MAS003664 RU 23-36

# Rapid Update 649

## MC20 – Radiator pipe coolant leak

DATE: AUGUST 1 2023

Example: Figure 1

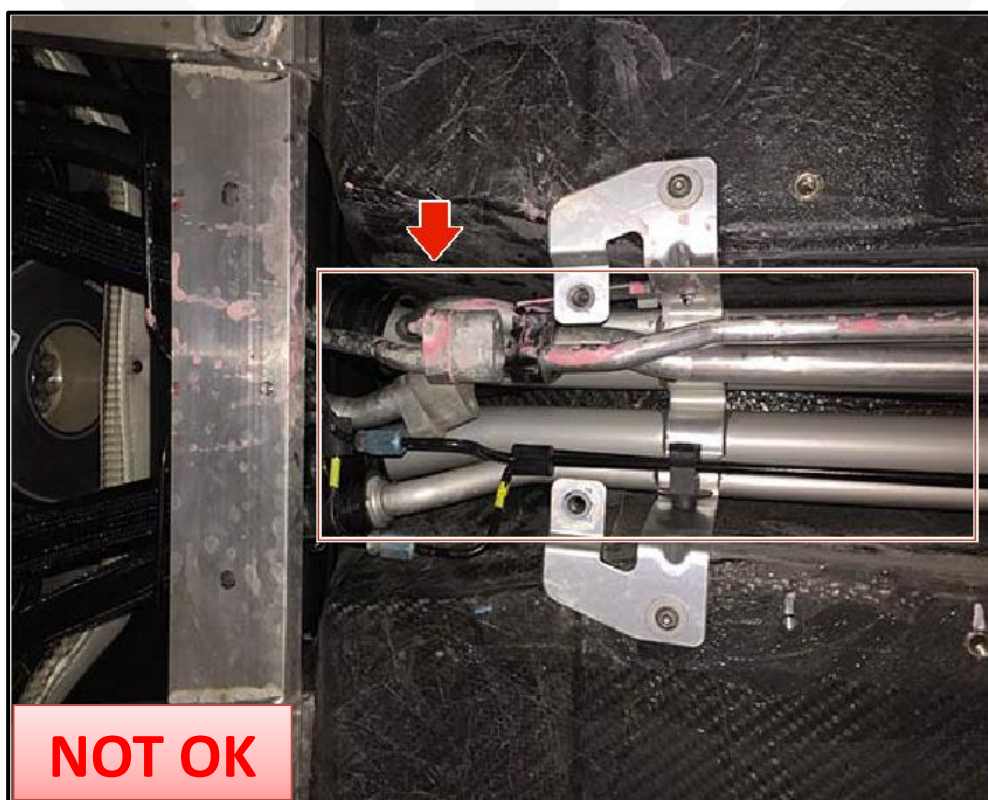
1. Always check ModisCS+ to see if the vehicle is involved in this action and if it has not been previously performed.
2. If thread lock has been used, refer to the following workshop section for bolt cleaning:
  - **00.AB.065 - THREADED ELEMENTS CLEANING TABLE**
3. Before performing this operation, please follow the indicated procedure for interior protection: **00.AA.005 - INTERIOR VEHICLE PROTECTION**
4. Safely lift the vehicle in the air.
5. Remove the body aerodynamic cover.
  - **09.14.089 - BODY AERODYNAMIC COVER - Removal/refitting or replacement**
6. Remove the rear aerodynamic central cover.
  - **09.14.090 - REAR AERODYNAMIC CENTRAL COVER - Removal/refitting or replacement**
7. Visually inspect for possible coolant leaks. (See example figure. 1)

- **OK** ▶ **No leak found:** No further action needed. ▶ Reinstall all removed components. Operation complete.
- **NOT OK** ▶ **Leak found:** Coolant leaks are present (pink spot on the pipe and the under body). ▶ **Continue to Step 9.**

Figure 2

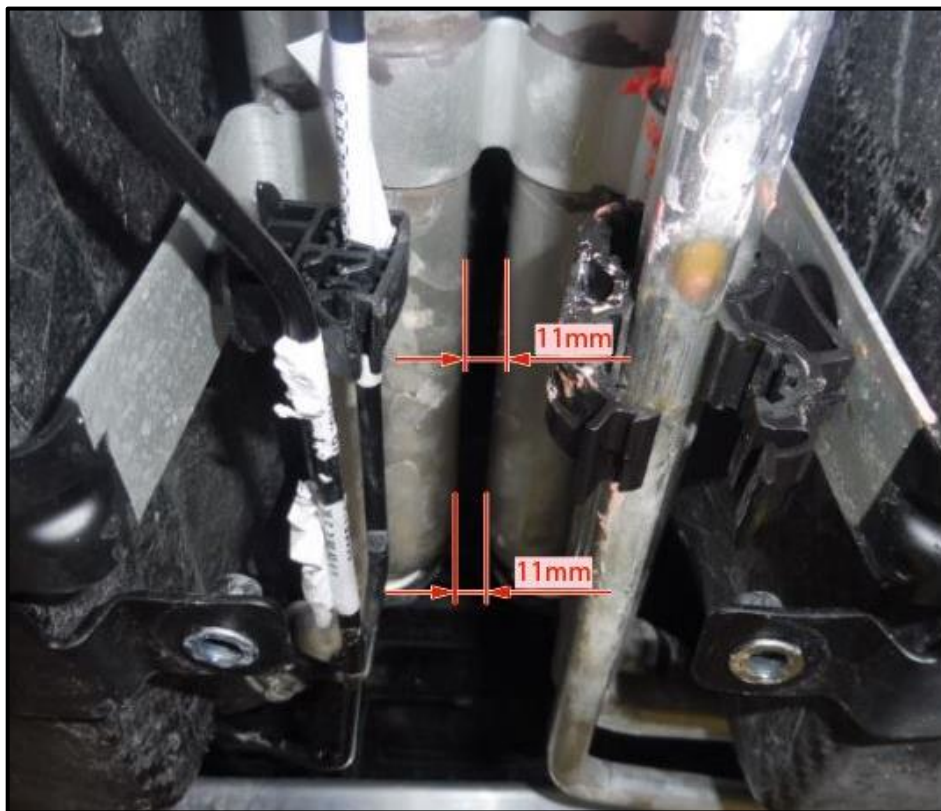
**NOTE:** For the pipes that did not pass inspection, there may be a deviation in spacing between the two from the bracket to the hose connection. The distance between the two pipes shown in figure 2 must be approximately the same (equally parallel around 11mm).

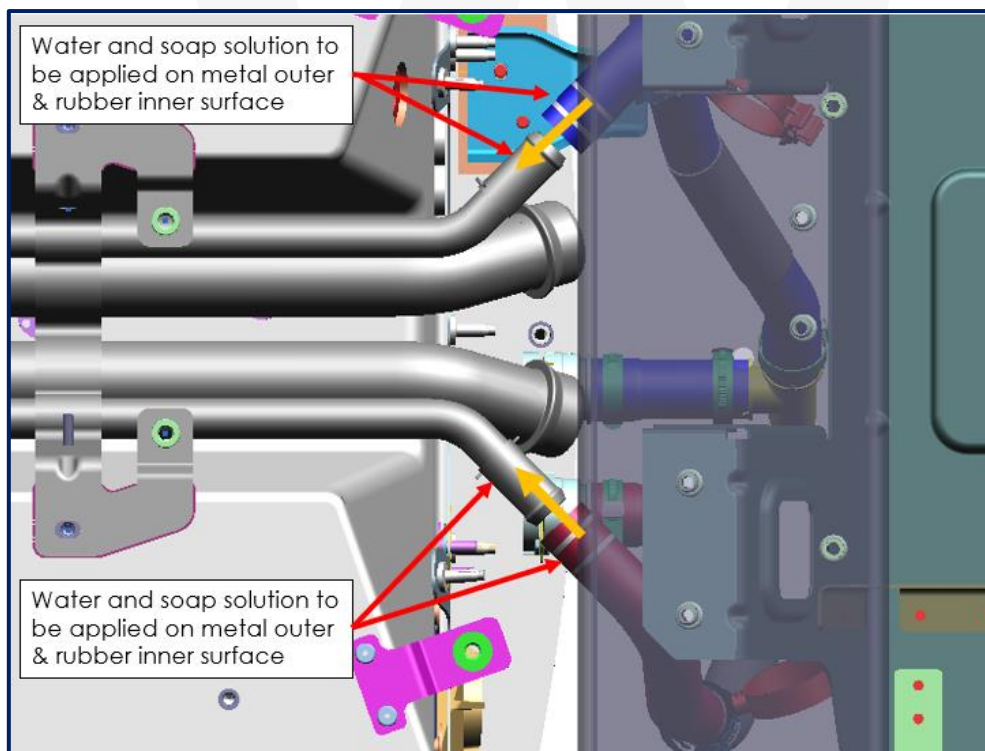
9. Perform the pipes replacement:

- **01.71.231 - REAR WATER PIPES - Removal/refitting or replacement**

**IMPORTANT:** When replacing the pipes, use a soapy water solution for easy insertion.
